Exposing the Risks:

**Fundamental Flaws in AGL's application
to frack CSG wells in Gloucester**

Fundamental Flaws in AGL's application to frack CSG wells in Gloucester (Review of Environmental Factors (REF))

Figure 2: Sample Deep Slotting Cross Section based on Stage 1A Profile Logs

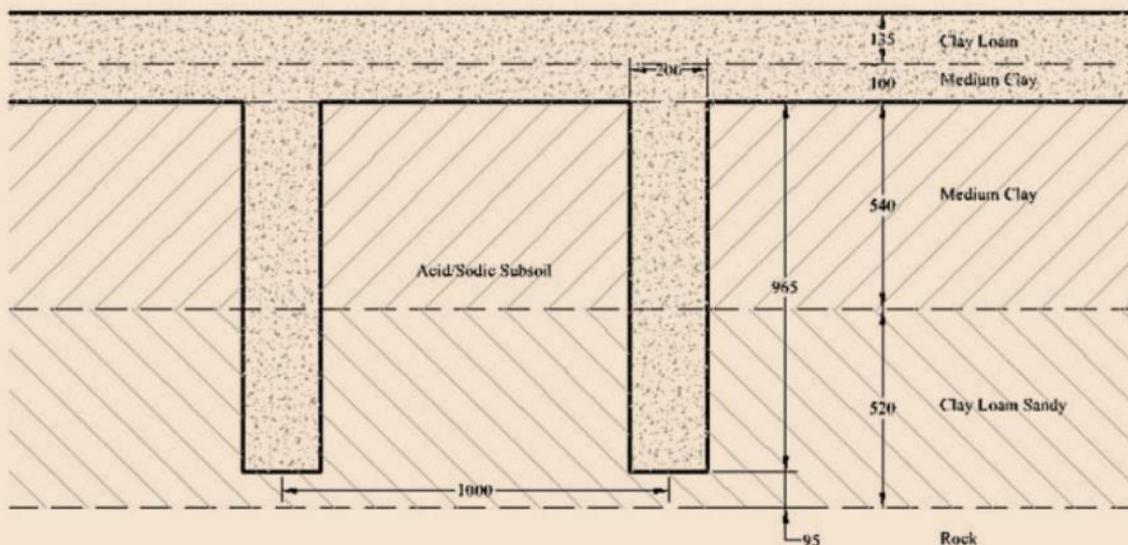
Figure 2 from FK 2012 is copied below and indicates that the slots are 200mm wide and spaced at 1000mm intervals across the surface but FK 2013 says the slots are 1500mm apart. Therefore, 12% of the soil is dug up and the ameliorant mixture is buried. This would not result in a

“thorough mixing of soil ameliorants’ as stated in the paragraph copied above. There will however be subsoil brought to the surface and this is not a good practice on Brown Sodosol soils.

The treatment or composition of the two top layers (135mm and 100mm) in Figure 2 cannot be understood due to lack of information. Section 8 of FK 2012 (reproduced below) provides some more information on this and suggests that the soil removed from the slots and the top 235mm are mixed with the ameliorants; then some of this mixture is put back into the slots and the remainder is spread across the surface at depths varied according to the depth of slots. The soil profile that results from this amount of physical and chemical change will be very complex in both the vertical and horizontal direction. This means that representative sampling will be complicated and require a large number of replications to avoid the bias of the slots.

FK Report 2012 Figure 4: Stage 1A Trial Irrigation Area showing location of soil sampling site (CS), shallow groundwater samplers (SP, piezometers) and soil moisture sensors (MS)

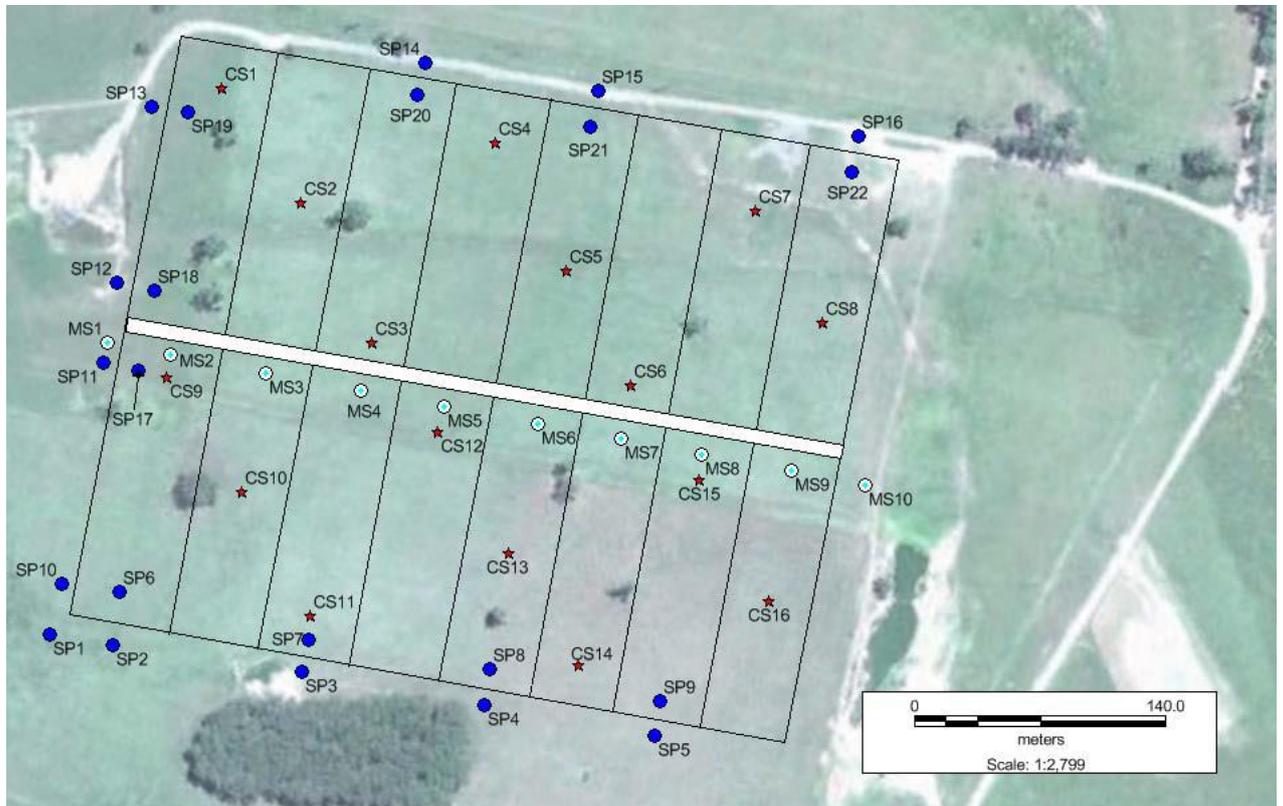
The first dot point is not a reasonable assumption because the variability across the site is so large (FK Annex 1 copied above). A statistical comparison is not possible with such a small sample size.

The second point is not acceptable because the soil surface has been substantially changed due to the trenching process and incorporation of large amounts of ‘ameliorants’. FK2013 Appendix 1 (reproduce here on the next page) indicates that there is a height difference of >10m across the site and can vary by 3-5m in any plot with different slope gradients within various plots.

The third point is incorrect because 1 sample per 0.77ha is not a high density of sampling for such analysis due to the very variable nature of the soil and its characteristics. This variability is demonstrated by the data presented (pages 3 - 4 above) from Annex 1 of FK 2012 that shows the minimum to maximum variations are three fold for many characteristics. There should be at least 7 and preferably 9 sample sites for each plot in order to adequately account for within treatment variation. The location of sample points in relation to the amelioration slots is critical to data interpretation but this is not discussed in FK 2012.

As presented in Figure 4, the soil sampling sites (CS) are somewhat on the contour lines (mapped in Sheet 01A of Annex 1 FK 2013) but this means they bear no relationship to the soil moisture sampling points (MS) and therefore no possible cause and effect relationships can be analysed between soil moisture and any other soil property. Similarly, there is no analysis possible of any relationship between soil moisture (MS) and groundwater (SP) because of the large spatial differences between sampling sites.

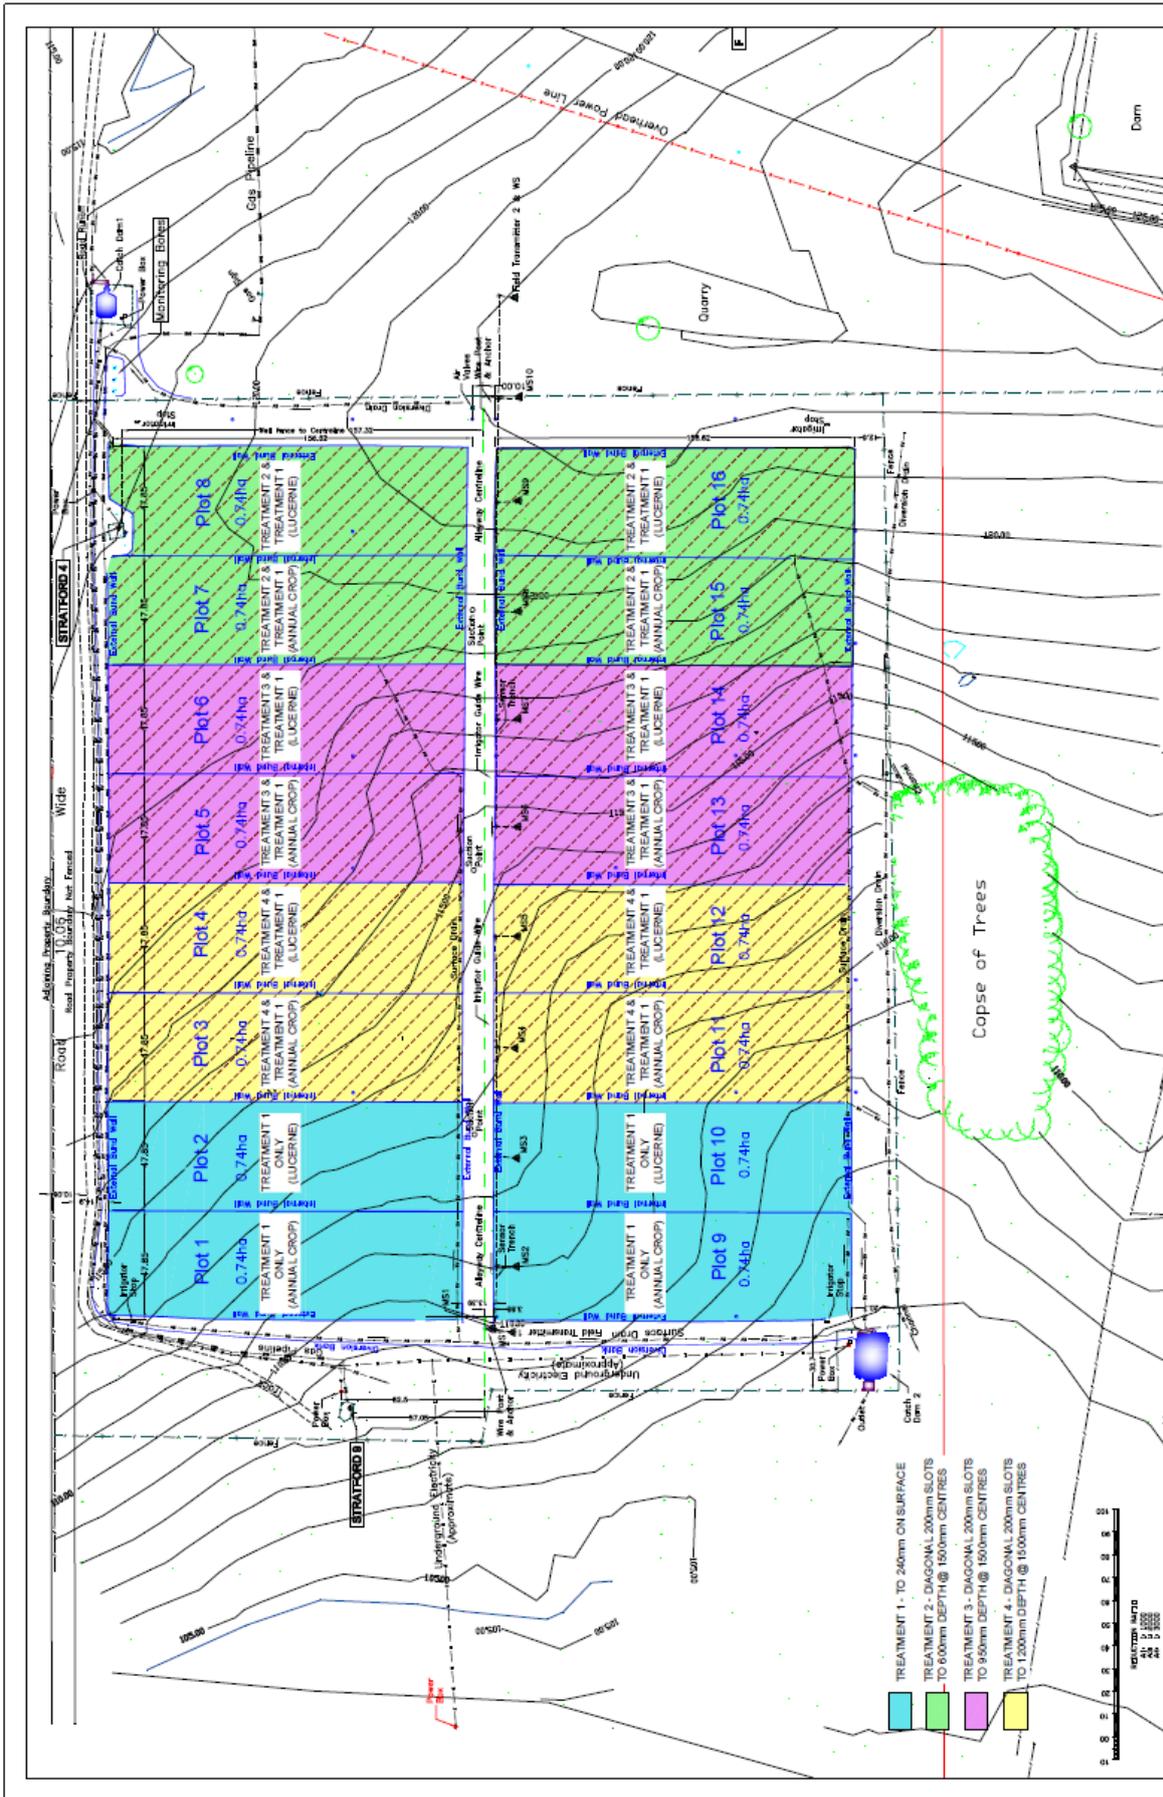
The only interpretation of this can be that the soil is being used as a massive 'sink' for up to 10T salt/ha/yr.

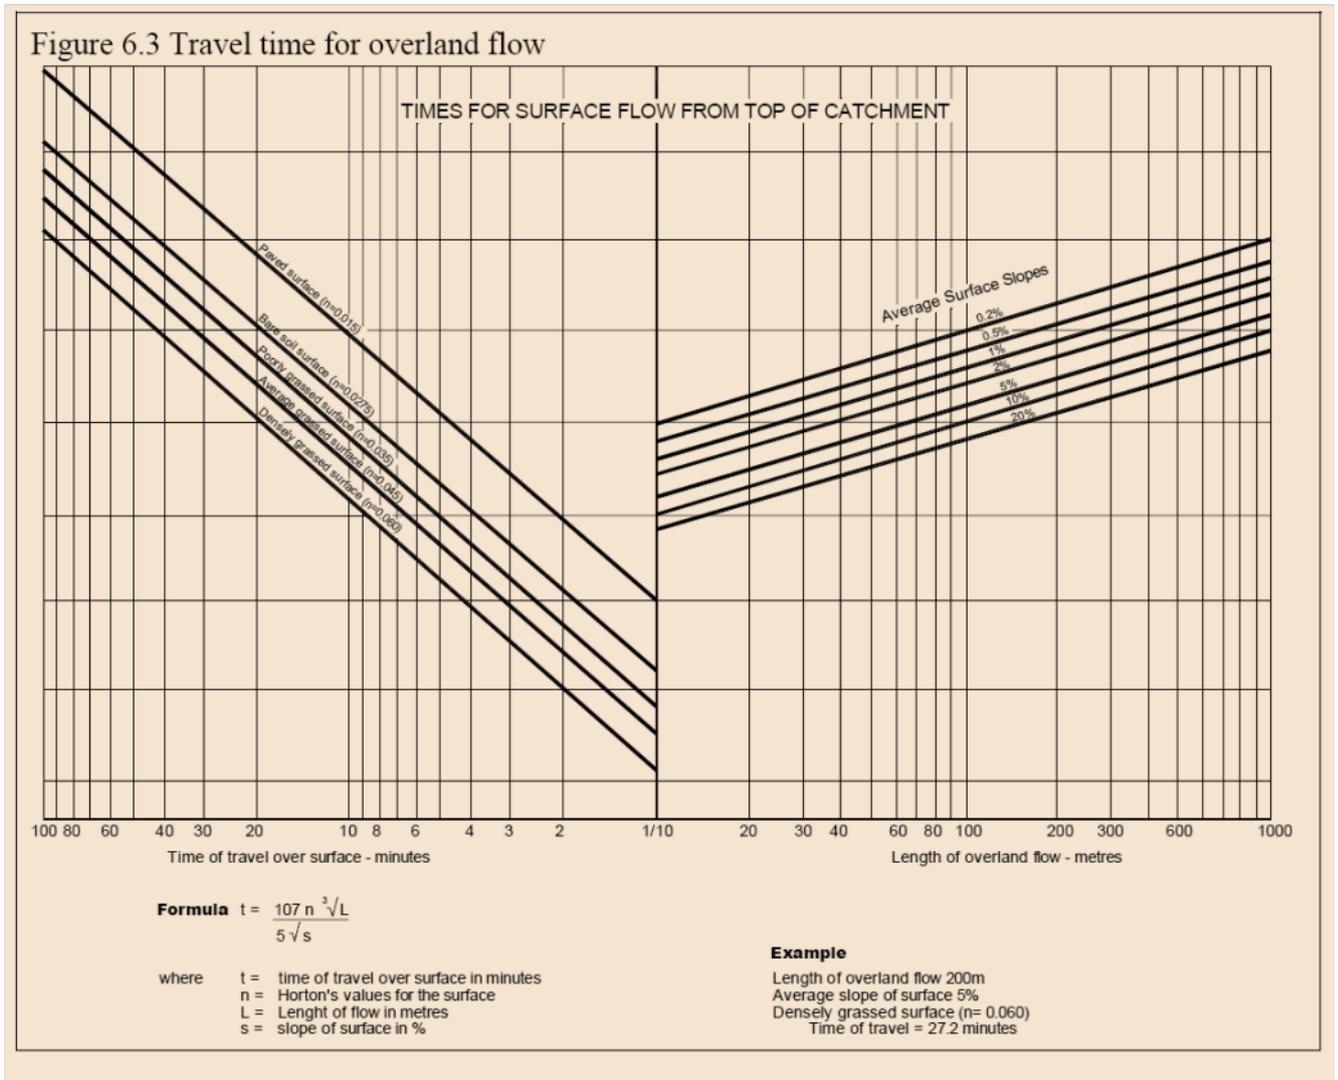
The calculation in Section 5.1 uses a rainfall intensity of 11.7mm/hr which from the Report Table 4 page 10 is the average rainfall intensity for a storm lasting 24hour with a 1:100 year return period. That is, the FK 2012 report is suggesting that the time of concentration for the plots is 24hours and this is not correct.
